3.7 PLANT SYSTEMS

3.7.16 Spent Fuel Assembly Storage

Figure 3.7.16-1
Required 3 out of 4 Loading Pattern for Restricted Storage

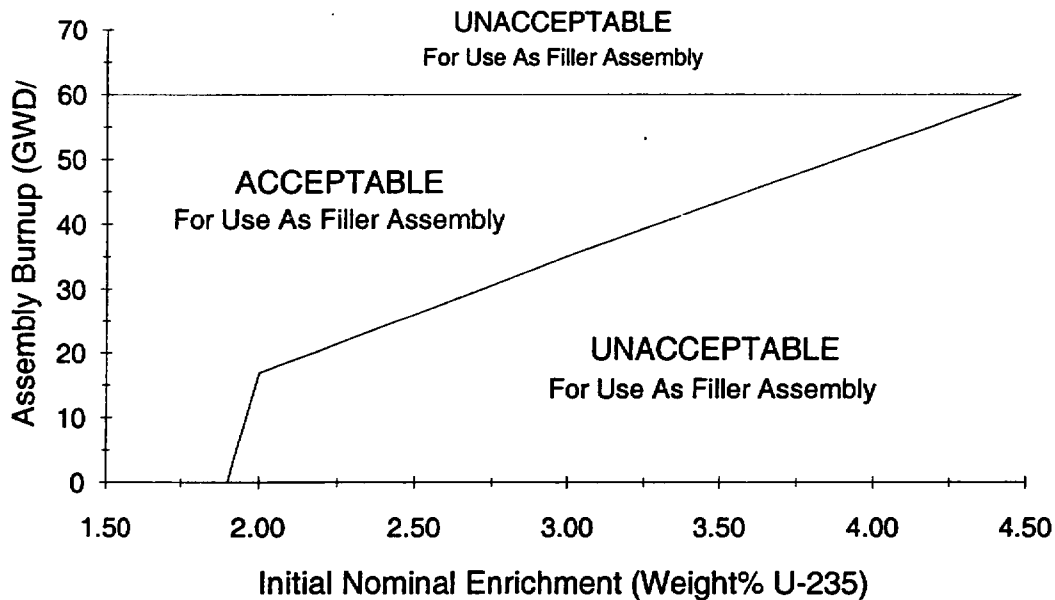
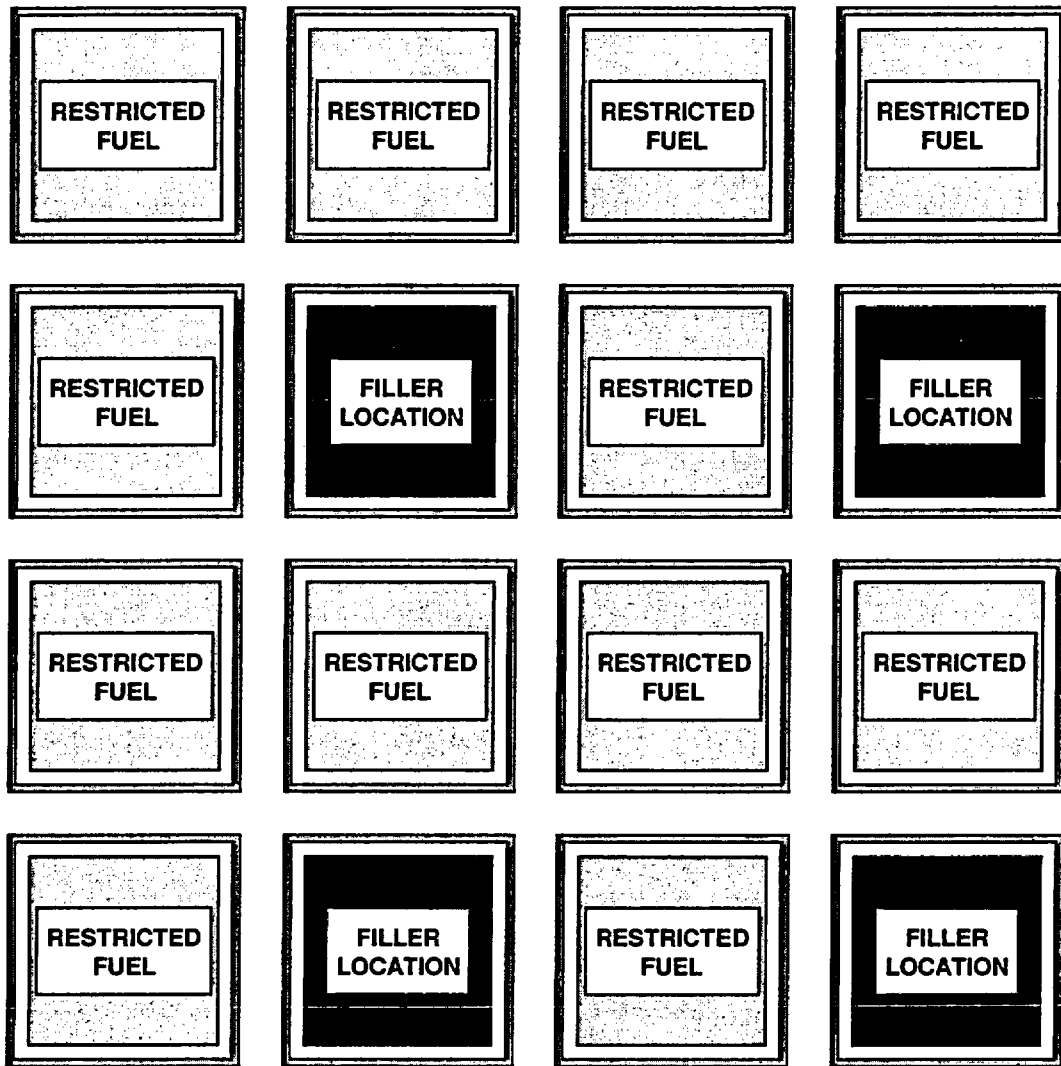
- a. Unrestricted storage (new or irradiated low enriched uranium fuel enriched up to an initial nominal 5.0 wt% U-235); or
- b. Restricted storage in accordance with Figure 3.7.16-1.

Restricted Fuel: Fuel which is a mixed oxide fuel assembly with a maximum nominal fissile plutonium concentration of 4.15 weight percent and a maximum nominal U-235 enrichment of 0.35 weight percent. (Fuel defined for Unrestricted Storage per LCO 3.7.16.a, or non-fuel components, or an empty cell may be used in Restricted Fuel locations as needed)

Filler Location: Either low enriched uranium fuel which meets the minimum burnup requirements of Table 3.7.16-1, or an empty cell.

Boundary Condition: Any row bounded by an Unrestricted Storage Area shall contain a combination of Restricted Fuel assemblies and filler locations arranged such that no Restricted Fuel assemblies are adjacent to each other. Example: In the figure above, row 1 or column 1 can not be adjacent to an Unrestricted Storage Area, but row 4 or column 4 can be.
